**Committee of Experts on the Transport of Dangerous Goods  
and on the Globally Harmonized System of Classification  
and Labelling of Chemicals**

**Considerations on document ST/SG/AC.10/C.3/2024/103 -  
Proposed changes to the Koenen test specifications**

**Submitted by the expert from Germany**

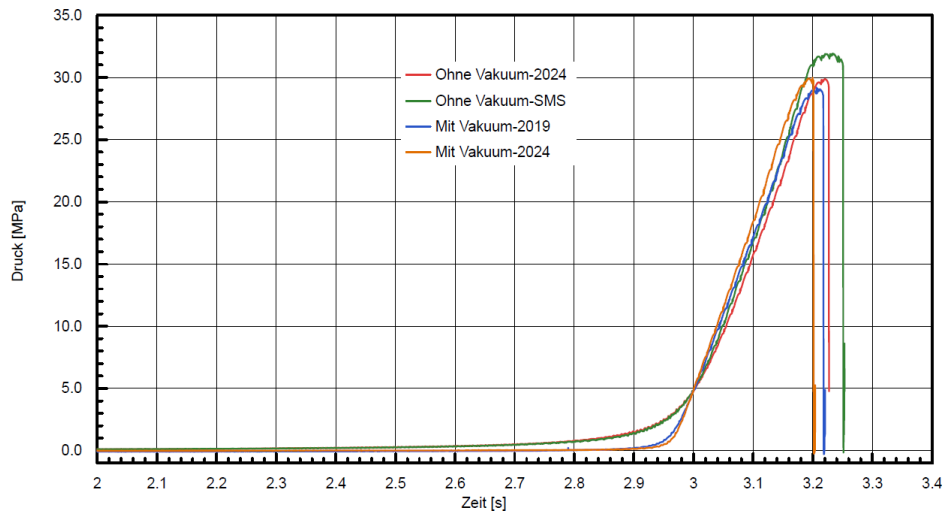
4. The second point concerns the dynamic burst pressure procedure. In the annex of the proposal in A12.2.3.3 it is described that “The entire system is purged of air, then the vacuum valve is closed...”. The expert from Germany wants to point out that this step is not necessarily needed because similar results are obtained, even if the air is not purged out before pressuring the tube. The standard procedure for determining the bursting pressure at BAM is that the tube is pressurized while the air is still present in the tube. The bursting pressure as well as the pressure rate of both methods are essentially the same as shown in the graph below.
